Town of Ridgeland

PROJECT: Town of Ridgeland Water and Sewer Resiliency Improvements
TOR-2023-02

ADDENDUM: Three (3)

A10.2

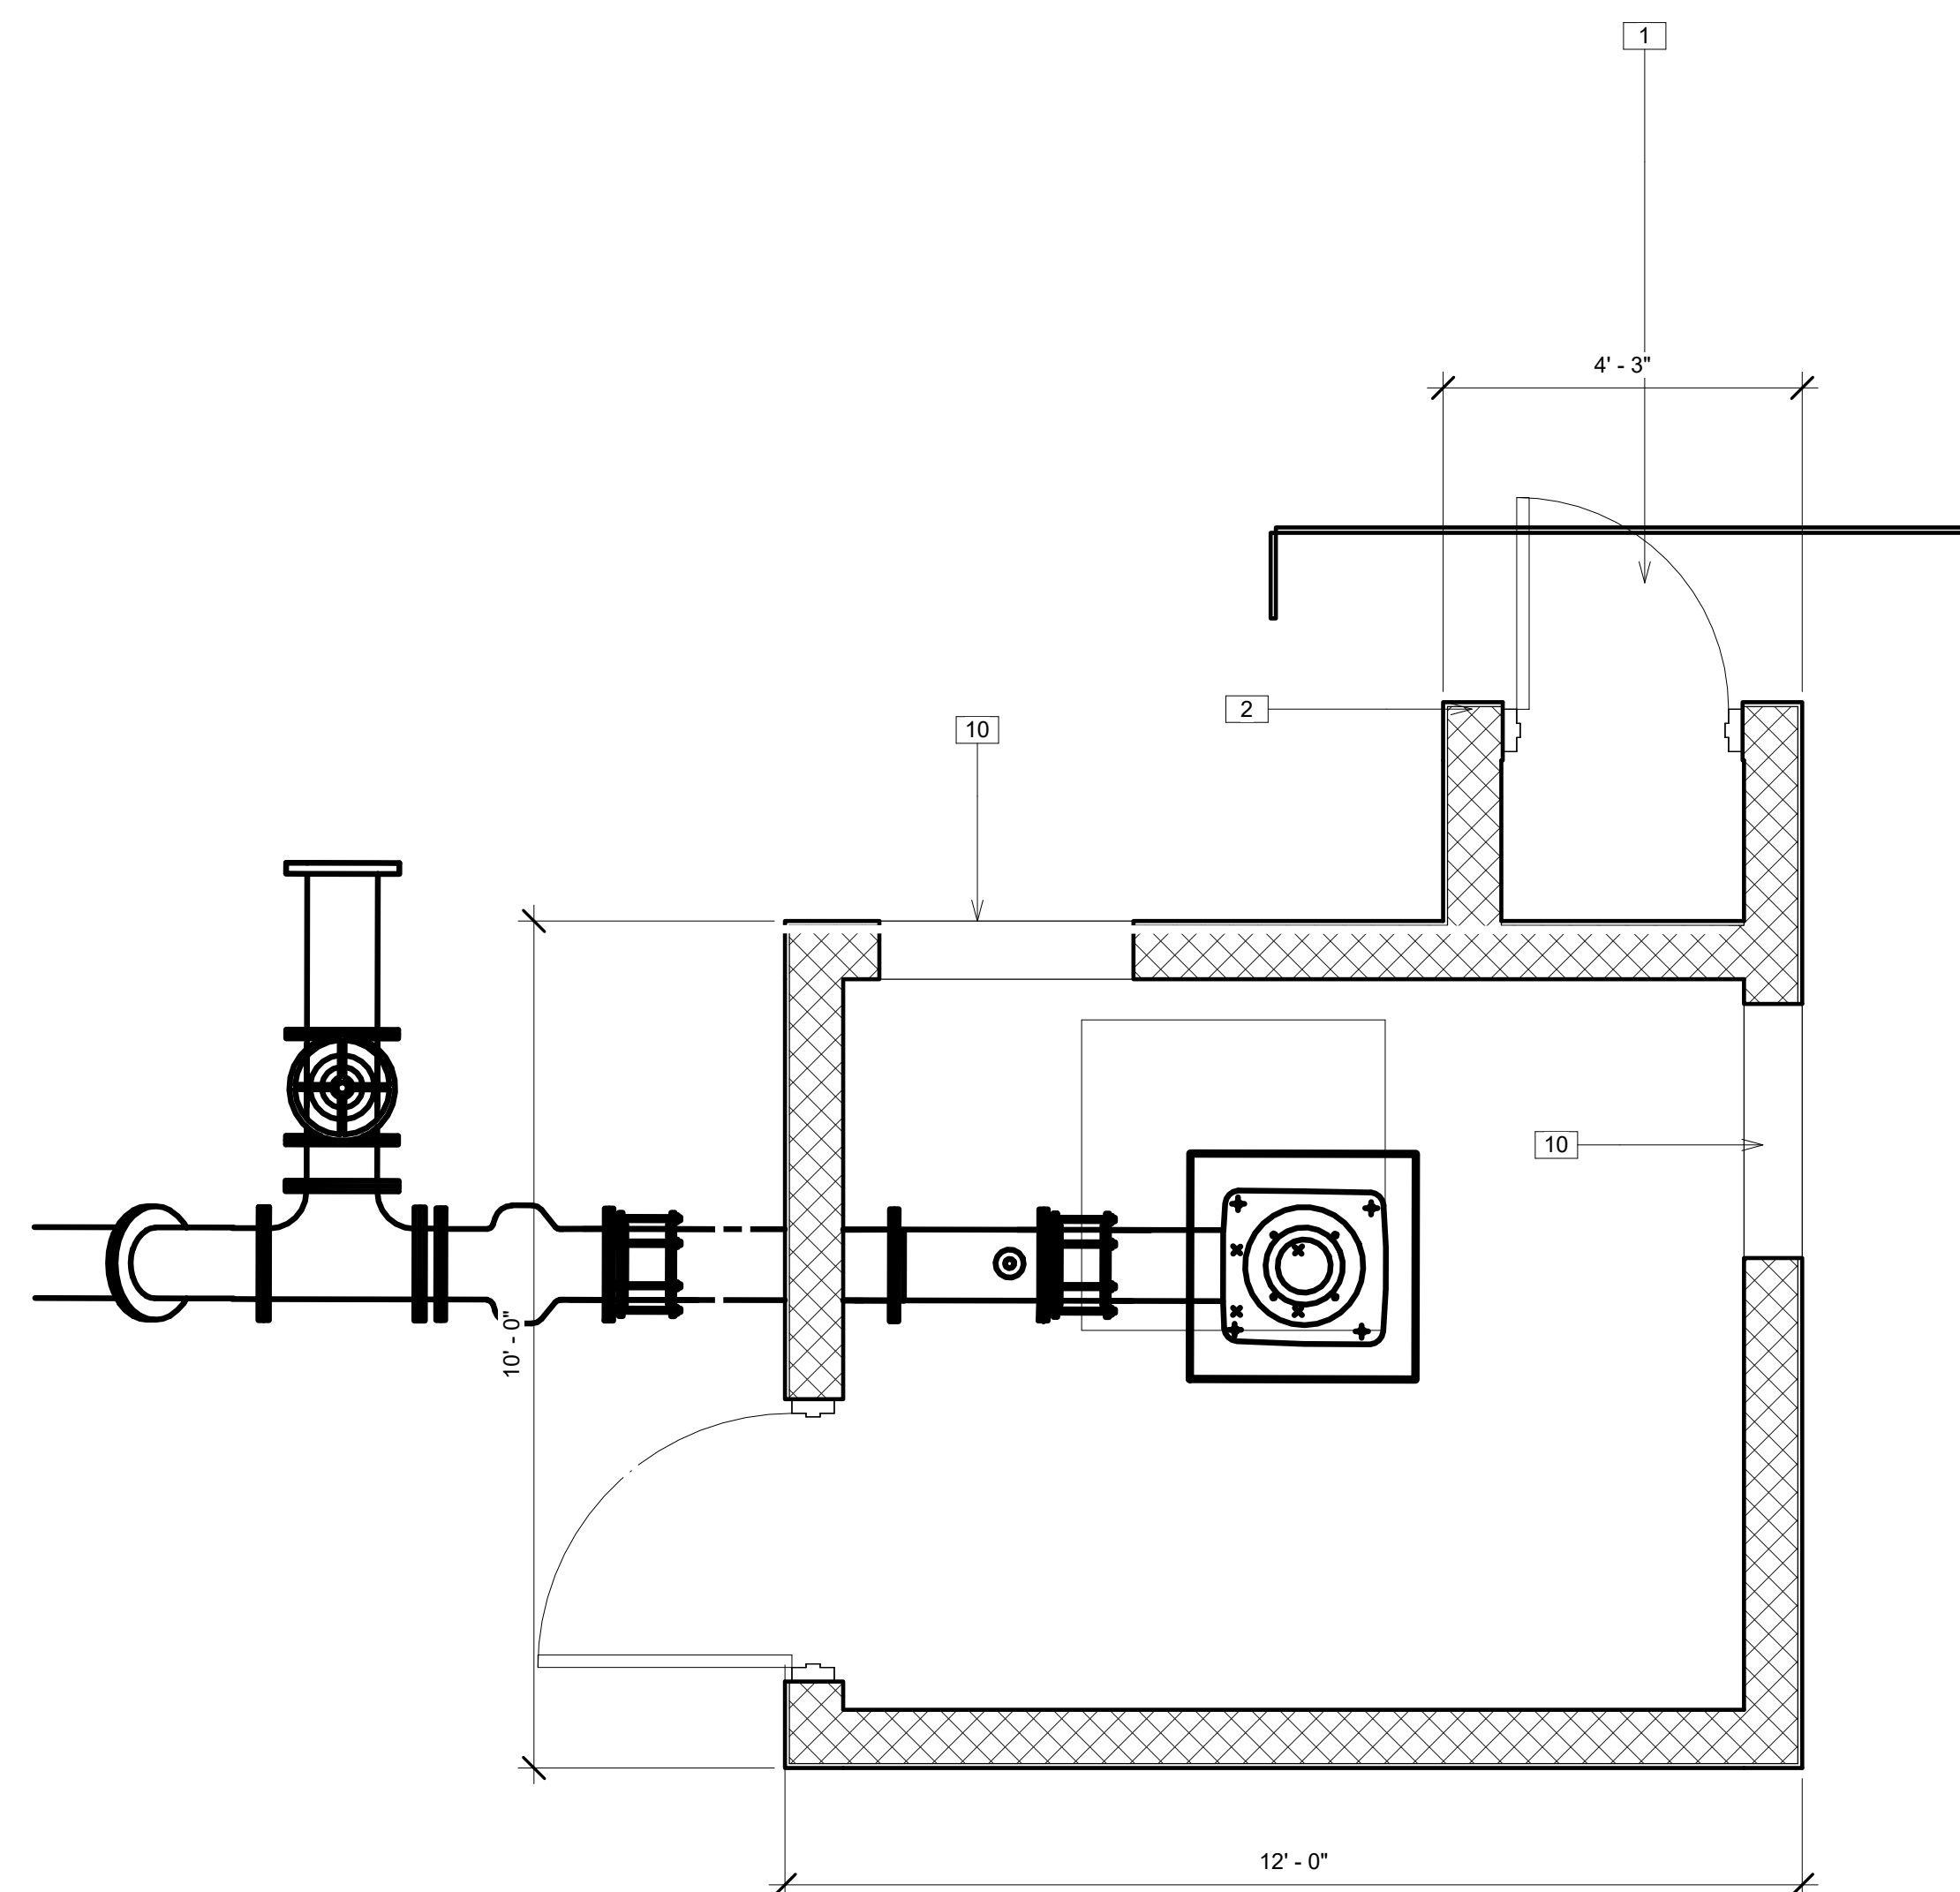
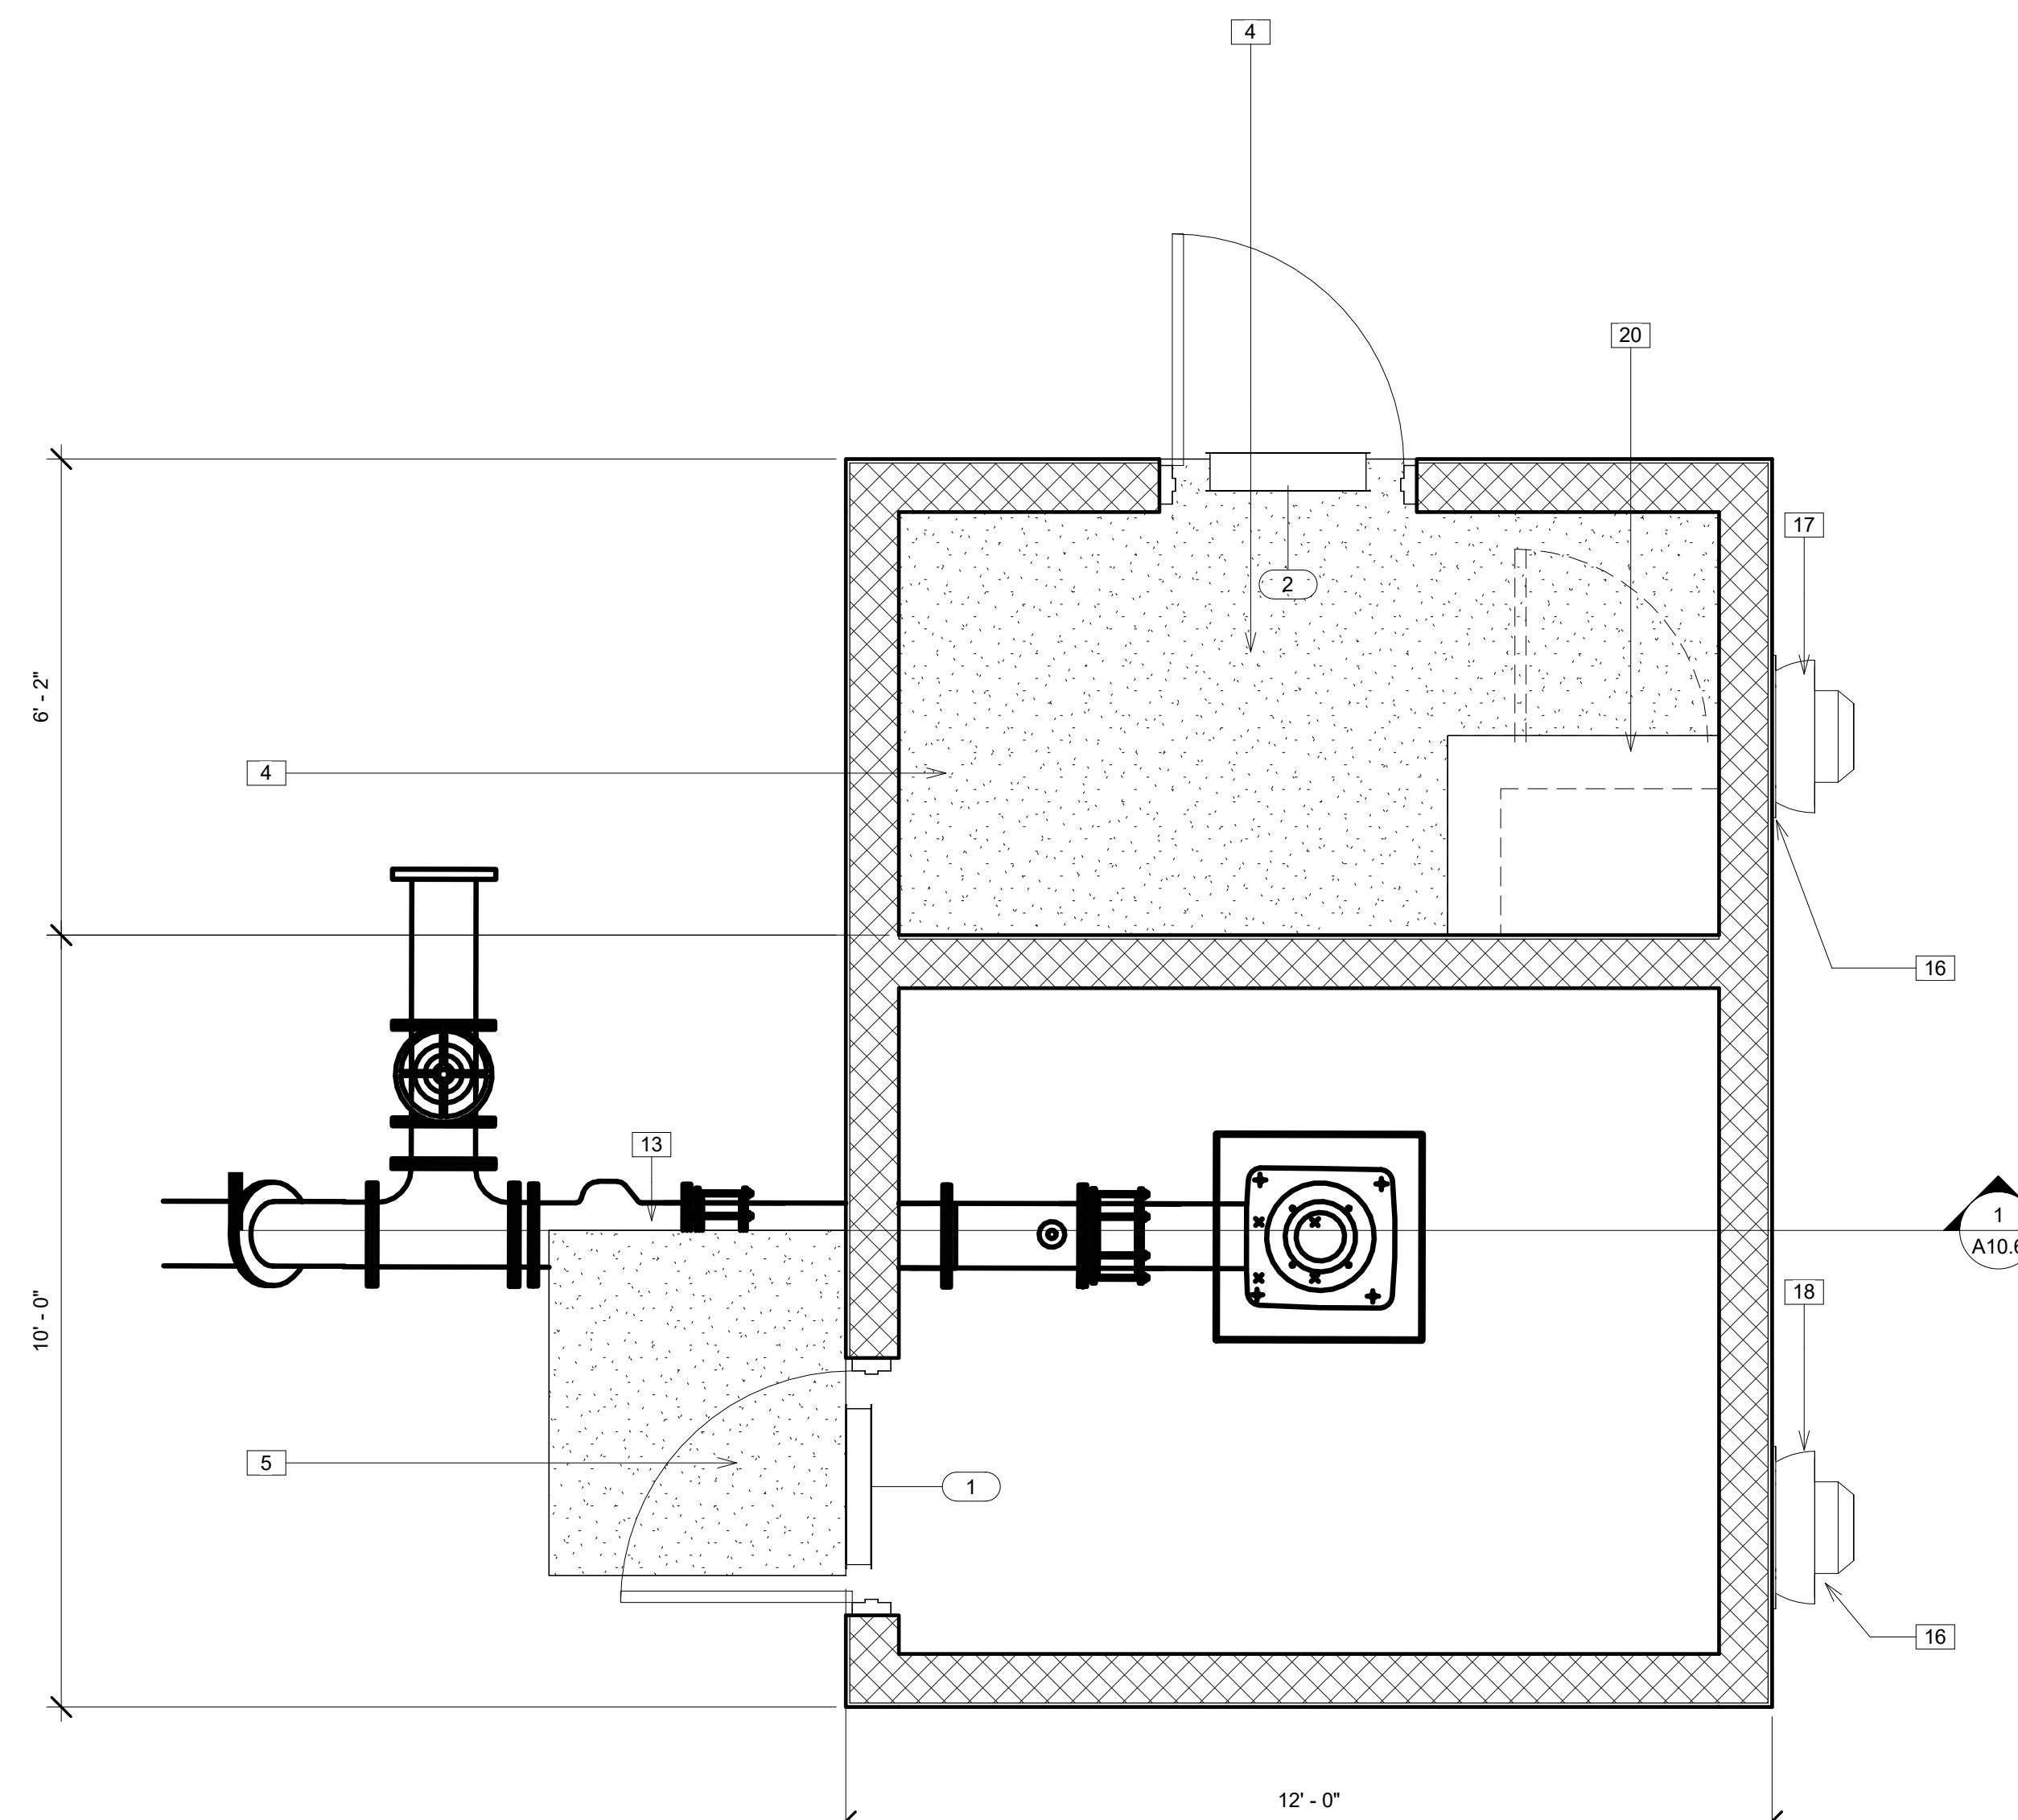
- i. A10, A10.1 – A10.7 Architectural improvements updates to correct dimensions of the existing building and to modify and increase the size of the proposed building expansion for the chemical room.
- ii. S100, S101, and S201 Structural improvements updates to correct dimensions of the existing building and to modify and increase the size of the proposed building expansion for the chemical room.
